REDLINE REVISION NO. 5
MD 175 AT DISNEY ROAD; REVISED POLE LOCATIONS IN THE NW QUADRANT

MD 175 (ANNAPOLIS ROAD) AT 26TH STREET/DISNEY ROAD)
FORT MEADE, MD

MOT PHASE 3 – TRAFFIC SIGNAL PLAN

TS NO. 1959D3 | DRAWING SG-13.3 OF 26 | SHEET NO. 133 OF 195

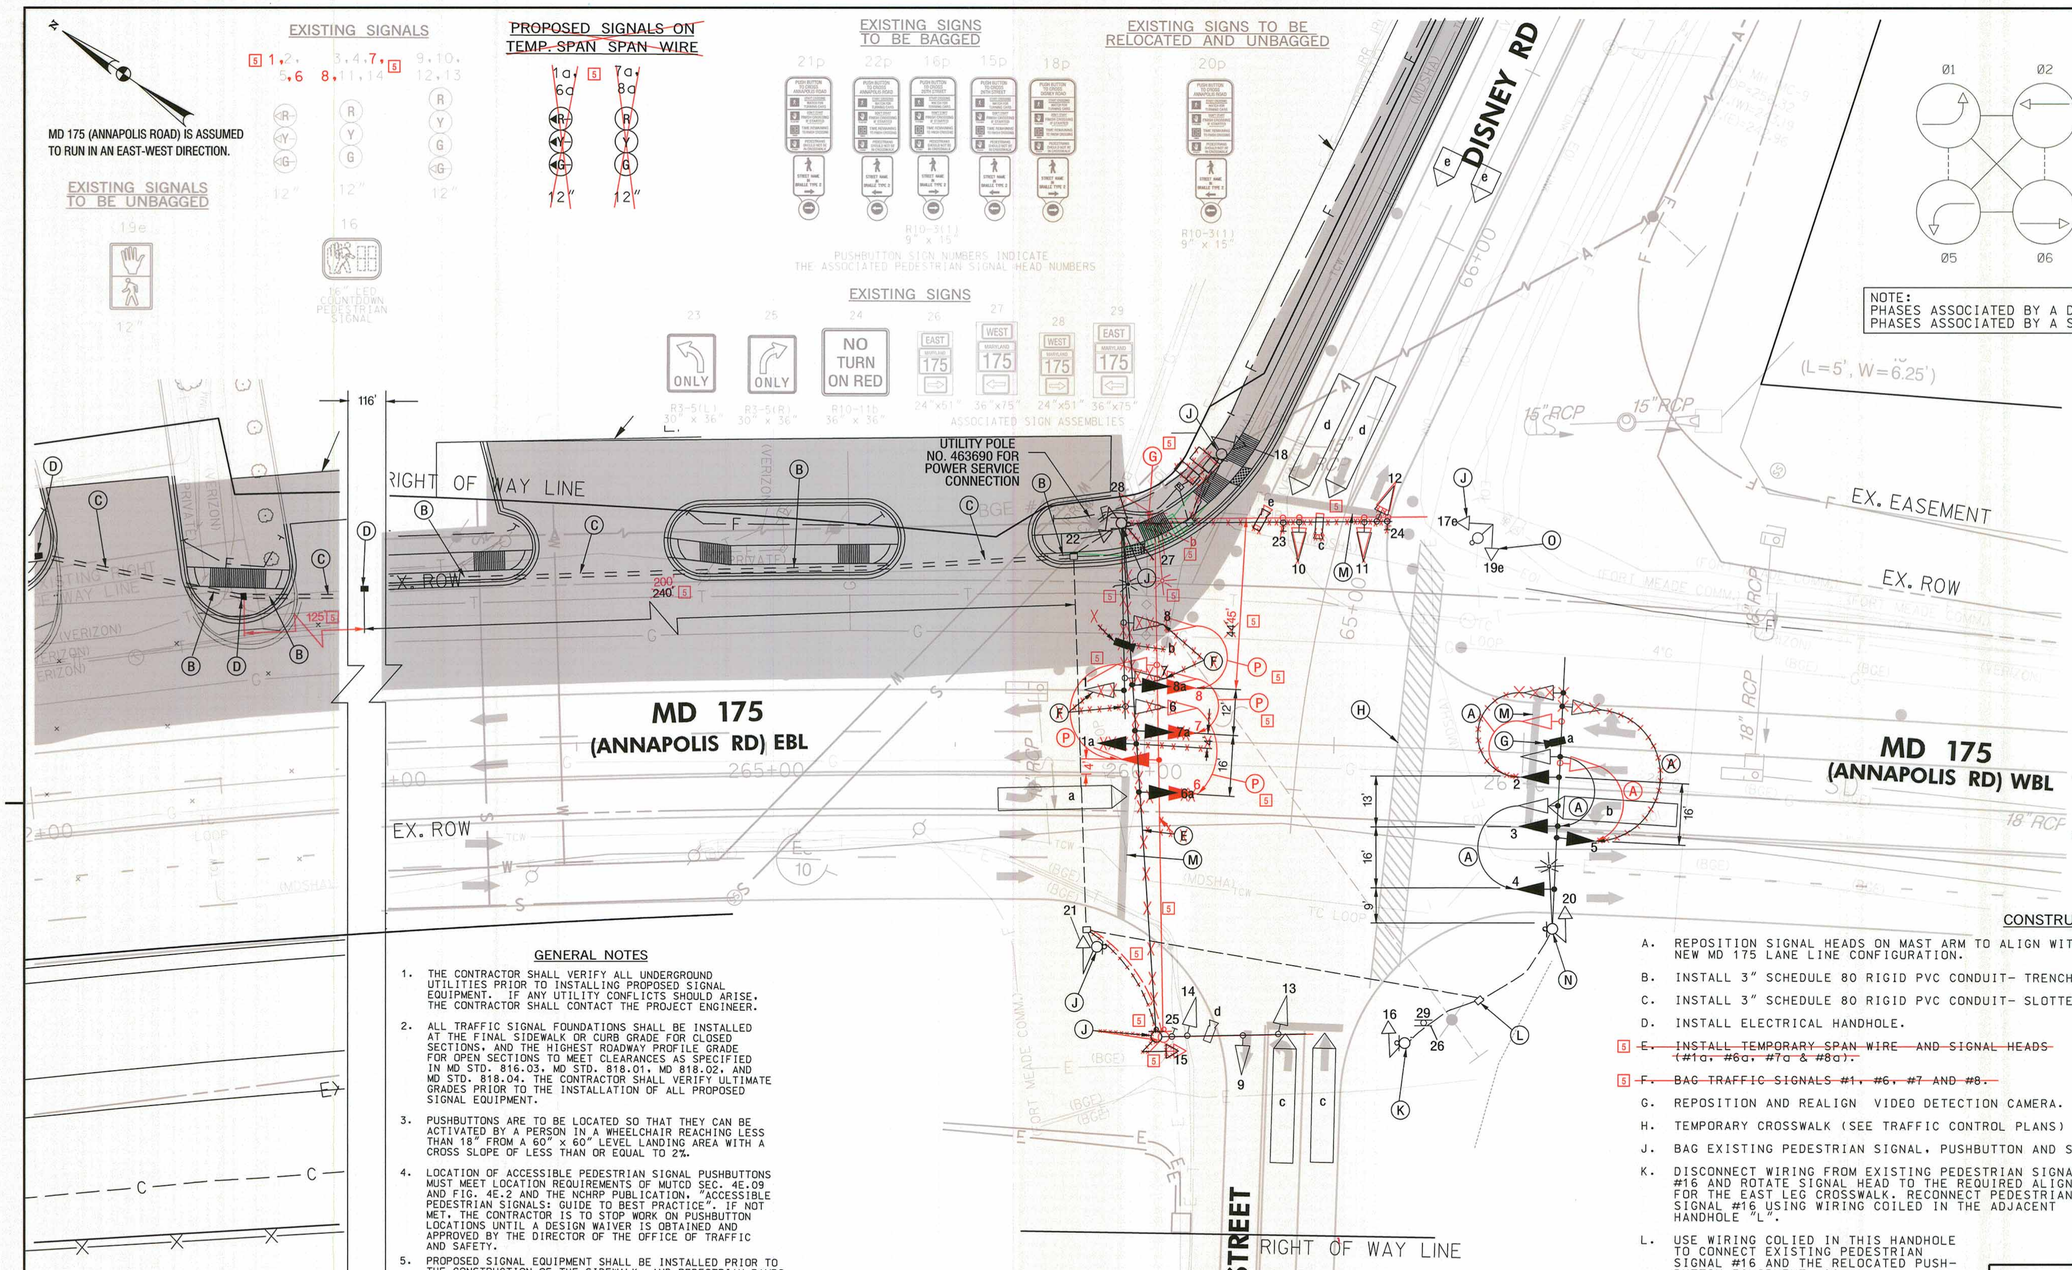
~~E. INSTALL TEMPORARY SPAN WIRE AND SIGNAL HEADS (#1a, #6a, #7a & #8a).~~

~~F. BAG TRAFFIC SIGNALS #1, #6, #7 AND #8.~~

REVISIONS
D 5 REDLINE NO. 5 1/ /2013 INSTALL NEW PEDESTAL POLE IN THE NW QUADRANT, RELOCATE SIGNAL POLE — ENB
D BRAC RECONSTRUCT TRAFFIC SIGNAL SHA #. AA5805370 10/2010 TIMS NO. J-969 — ENB
C 1/24/97 ASBUILT SHA#: BW8608025I2 — RRZ
